Office Action Summary

10/590,139

DETAILED ACTION

FIG. 25

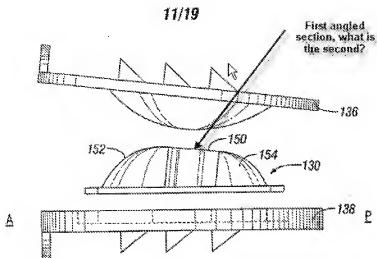
Regarding claim 32, *“first and second bearing surfaces positioned between the first and second bone engagement surface, at least one of the first and second bearing surfaces comprises an angled section”* is indefinite. It can be interpreted that bearing surface 150 comprises and an angled section relative to the lower plate 138. But what is the second bearing surface which comprises an angled section? Why is it considered angled? Additionally, the claim language implies that is might be angled or might not be angled. Which is correct?

Applicant's claims use very broad claim terminology which is not supported by the specification. Due to the very broad language which confusingly can be describing various surfaces, or portions thereof, the claim is indefinite. The following claim limitations are indefinite: first and second articulating surfaces, third and fourth articulating surfaces.

Fig. 1

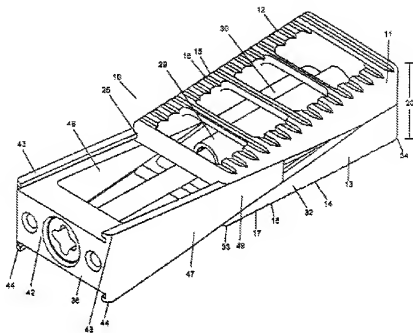
Baynham et al teaches an intervertebral disc prosthesis comprising first and second bone engagement surfaces (self-evident) and a nucleus 42 positioned therebetween. Said nucleus having a first bearing surface having a first straight portion (self-evident) opposite a planar bearing surface (self-evident) which are non-zero slope relatively oriented.
